विषय- प्रस्तावित १३२ के. व्ही. मुल ते सिकॉम चंद्रपूर द्विपथ वीज वाहिनीकरीता राज्य व राष्ट्रीय वन्यजीव मंडळाची मान्यतेकरीता.

Sub:- Diversion of 44.0397 ha forest land under the forest (Conservation) Act, 1980 for laying of 132 KV D/C Mul-SICOM Chandrapur transmission line.

..... Request to move the proposal to REC, Nagpur through Government of Maharashtra for reconsideration of the condition no. xii stipulated in Stage-I approval thereof..

132 KV Tower Key Diagram

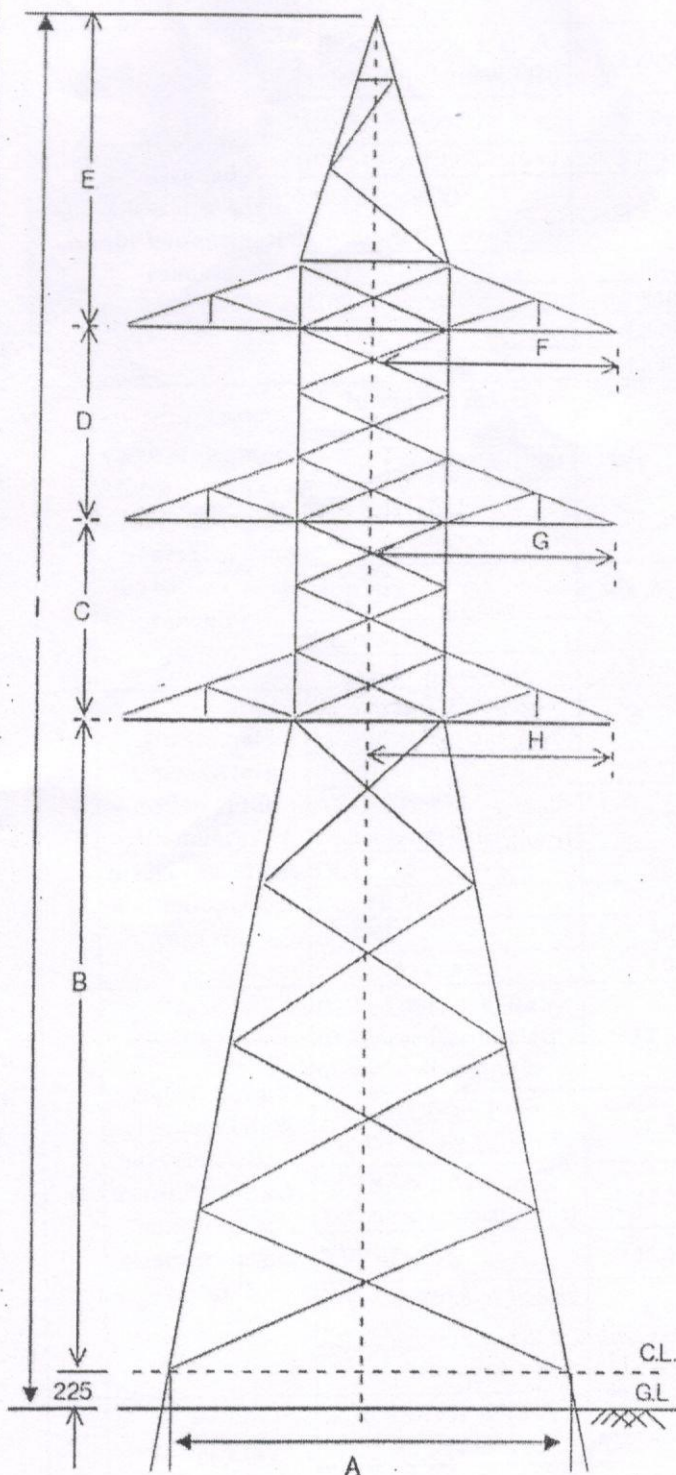
१. ब) दोन कंडक्टर (वायर) मधील अंतर ८ मीटर पेक्षा जास्त ठेवावा जेणेकरून पक्षी अडणार नाही.

- (a) Ground clearance of lowest (bottom) conductor (wire) should be more than 9 meters
- (b) Spacing between two conductors (wire) should be more than 8 meters so that birds could not be entangled within.

त्यानुसार असे दिसून येते की सदर वाहिनीच्या दोन कंडक्टर मधील अंतर हे किमान ३.९ मीटर एवढे असणार आहे. अशाप्रकारचेच मनोरे हे संपूर्ण महाराष्ट्रात वर्षानुवर्ष कार्यरत असून त्यामध्ये पक्षी अडकण्याची घटना घडत नसल्याचेही निदर्शनास येते. तरी दोन कंडक्टर मधील अंतर ८ मिटर एवजी ३.९० मिटर ठेवण्याबाबत अटीमध्ये सुधारणा करण्यात यावी.”

वरील निवेदनाचे अनुषंगाने प्रस्तुत बाब राज्य वन्यजीव मंडळाचे दिनांक १६/१०/२०२३ रोजीच्या २२ व्या बैठकीत अट सुधारणा करणेबाबत मंडळाच्या निर्णयार्थ सादर करण्यात आले होते. मंडळाने प्रकल्प यंत्रणेच्या वरील निवेदनानुसार अट सुधारणा करण्यास मान्यता प्रदान करण्यात केलेली आहे.

Now, we wish to draw your kind attention towards the fact that 132kV tower design that is used in Maharashtra by MSETCL have the standard ground clearance of minimum 6.10 meters and spacing between the two conductors shall be 3.90 meters. The standard Key Diagram of 132kV Tower is enclosed herewith for your ready reference. Further, as per Indian Electricity Rule 1956 and Electricity Authority Regulation 2010, the minimum ground clearance for 132kV Transmission Line should not be less than 6.10 meters. As such, our standard design of 132kV Towers obeys the guidelines issued by Central & State Government. Further, the query was raised on the spacing of 3.90 meters between two conductors citing the reason of entanglement of birds. It is to be noted that practice of spacing between two conductors 3.90 meters apart is followed throughout the Maharashtra by MSETCL and no such incident of bird entanglement is happened till date.

In the graveness of matter elaborated above, it is now once again requested to consider our request of maintaining minimum 6.10 meters of ground clearance and, the distance between two conductors is 3.9 meters instead of 8 meters & Compliances of the other conditions of Forest Department related to this 132kV D/C Mul-SICOM Line will be complied by MSETCL.
